Memorandum

To:	Stillwater Township Town Board Supervisors	**Project Reference:**	Rydeen Minor Subdivision Request
Copies To:	Barbara Riehle, Clerk		
	Doug and Jean Rydeen, Property Owners	**TKDA Project No.:**	22430.0000
From:	CJ Sycks, Planner	**Client No.:**	
Date:	August 8, 2025

SUBJECT: Minor Subdivision of 16XXX 110th Street North

Figure 1: Excerpt from submittal, dated 6-2-2025, Preliminary Plat

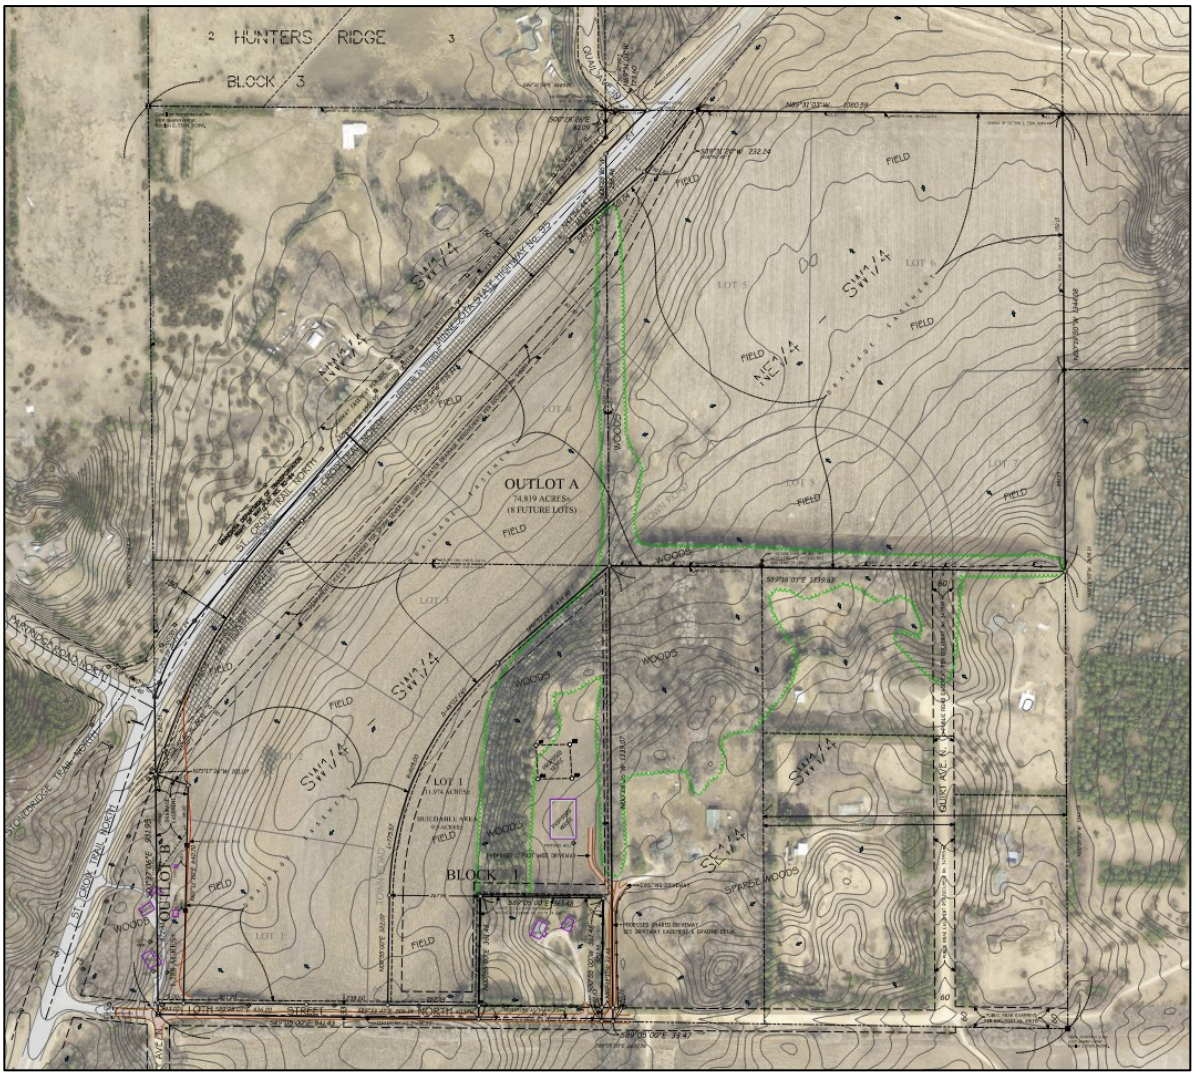
The minimum lot size in the Agricultural zoning district is 10 acres. Lots must also have a minimum of 300 feet of frontage on a public road. Lot 1 is proposed to be 11.974 acres in size, with 301.01 feet of frontage.

This criterion is met. The proposal would result in three parcels.

1. The minor subdivision shall adhere to the dimensions proposed in the preliminary plat dated 6/2/25 and final plat dated 8/6/25, submitted to the Township and reviewed with this request.

Figure 2: Excerpt from submittal, received and dated 8-6-2025, Final Plat

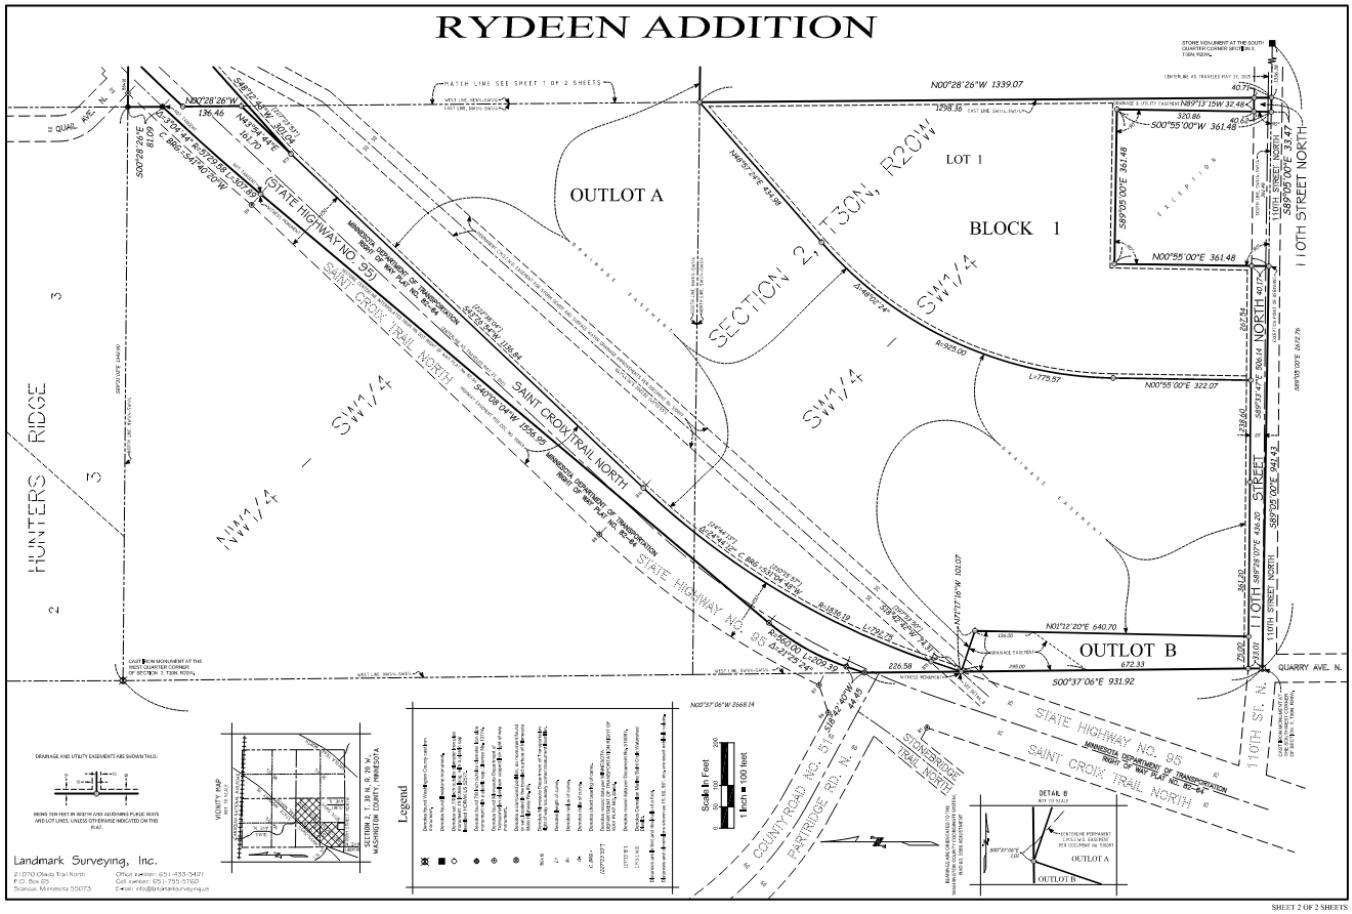
- Carnelian-Marine Saint Croix Watershed District (CMSCWD)
  - "The proposed subdivision doesn't trigger the need for any District permit and the plats call out the existing utility and drainage easement for the Little Carnelian outlet pipe. So no additional comments from the watershed."

- Washington County
  - Washington County performed a first review of the final plat on 6/4/25 and a second review on 8/5/25. The applicants have incorporated the comments into a new final plat.

4. The Applicant shall record the final plat with Washington County within twelve months of preliminary plat approval (8/14/2025).
5. The Applicant shall record driveway agreement easement and final plat with Washington County within twelve months of preliminary plat approval (8/14/2025).
